PROJECT CONSISTS OF INSTALLATION OF AN AIRPORT LIGHTING SYSTEM AT THE FRANKLIN COUNTY STATE AIRPORT. SYSTEM ~~TO BE~~ INSTALLED INCLUDES: MIRLS, MTLS, REILS, ROTATING BEACON, LIGHTED WIND CONE & SEGMENTED CIRCLE. THE PROJECT ALSO INCLUDES CONSTRUCTION OF AN AIRPORT ELECTRICAL VAULT, VISUAL APPROACH SLOPE INDICATOR AND TAXIWAY GUIDANCE SIGNS.

PROJECT № AIR 03-2029

AS BUILT PLANS

FRANKLIN COUNTY STATE AIRPORT
SCHEMATIC SHEET

RUNWAY LIGHTING & REILS CIRCUITS

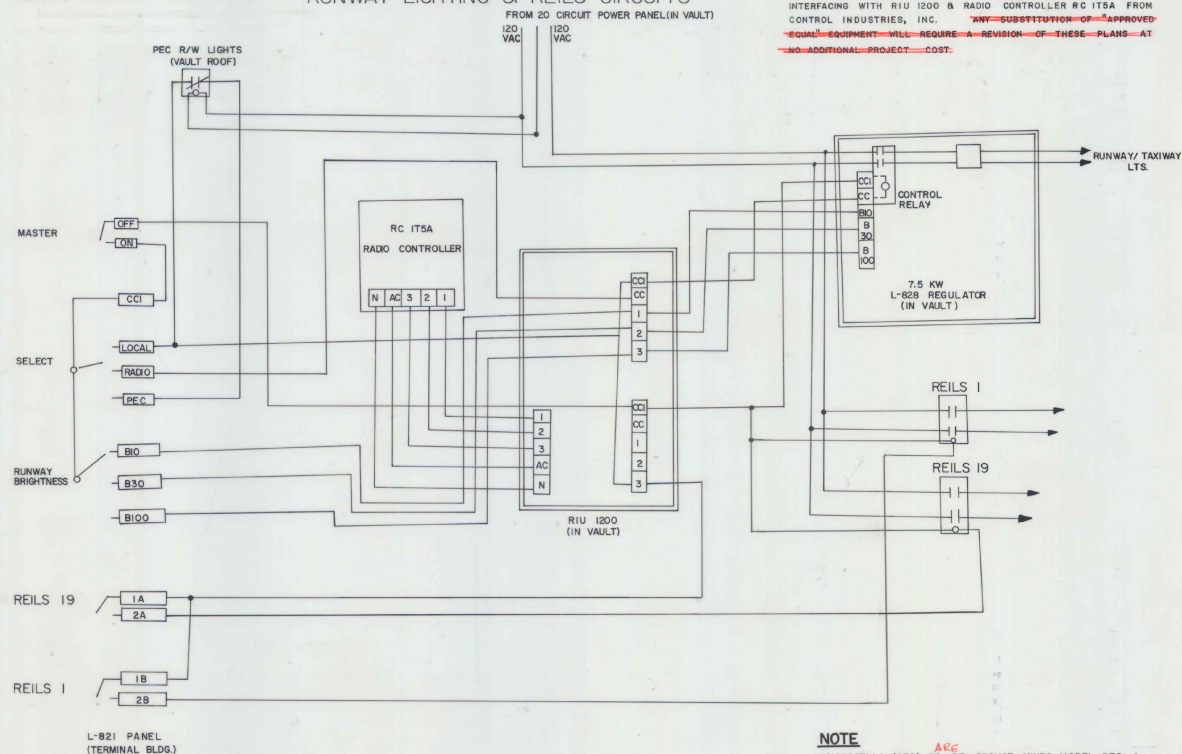
THE WIRING DIAGRAM SHOWN BELOW IS DESIGNED FOR USE WITH RADIO
INTERFACING WITH RIU 1200 & RADIO CONTROLLER RC 1T5A FROM
CONTROL INDUSTRIES, INC. ~~ANY SUBSTITUTION OF "APPROVED~~
~~EQUAL" EQUIPMENT WILL REQUIRE A REVISION OF THESE PLANS AT~~
~~NO ADDITIONAL PROJECT COST.~~

WIND CONE-BEACON CIRCUITS

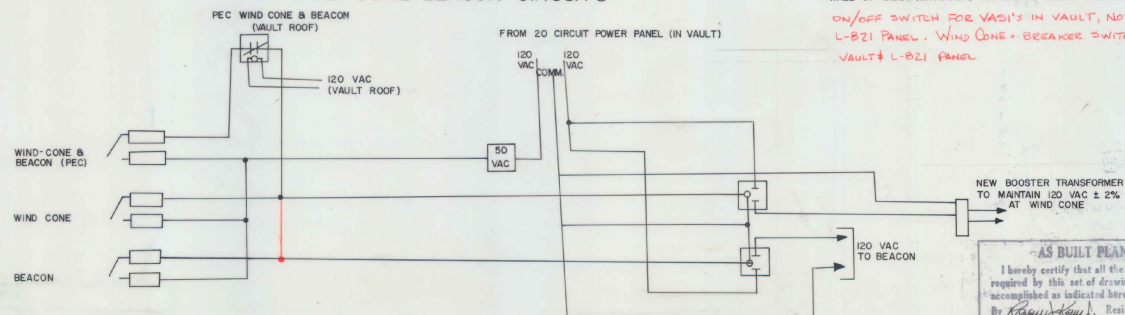
PHOTOCELLS (PEC) ~~TO BE~~ ^{ARE} CROUSE-HINDS MODEL PEC-4
OR AN APPROVED EQUAL. BOTH ~~TO BE~~ MOUNTED ON NORTH
WALL OF VAULT (EXTERIOR) APPROX. 8' ABOVE GROUND.

ON/OFF SWITCH FOR VASI'S IN VAULT, NOT ON L-821 PANEL. WIND CONE - BREAKER SWITCH IN VAULT $\neq$ L-821 PANEL.

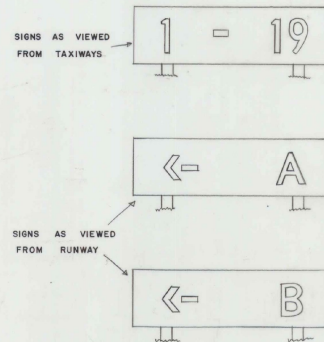
NOTE: LATERAL OFFSET OF REILS FROM EDGE OF R/W
~~SHOULD BE~~ 75' FROM R/W I. (BECAUSE OF
TWO BOX VISUAL APPROACH SLOPE INDICATOR INSTALLATION)

FRANKLIN COUNTY
STATE AIRPORT
DISPOSITION OF OBSTRUCTIONS

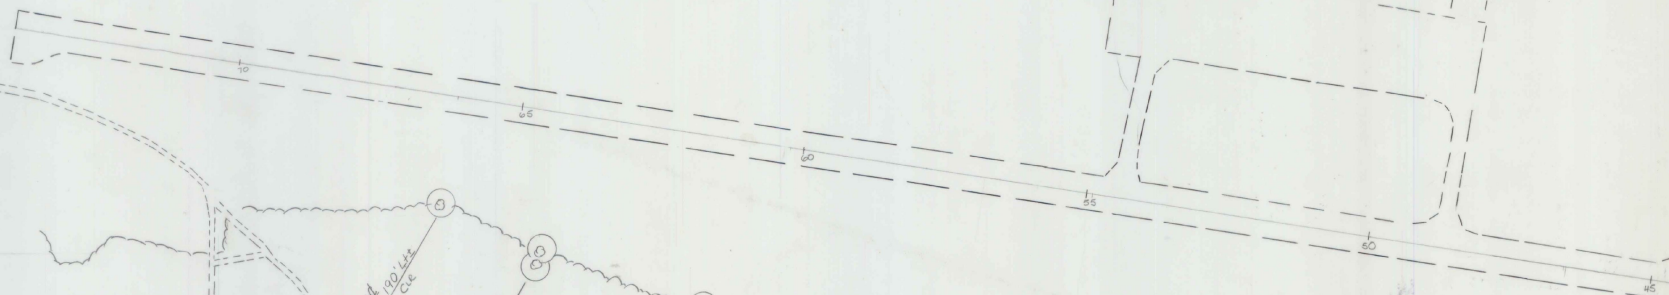
NOTE: ITEM 201.10, CLEARING & GRUBBING PLUS INDIV. TREES & STUMPS DELETED FROM CONTRACT. WORK ACCOMPLISHED BY DISTRICT FORCES.
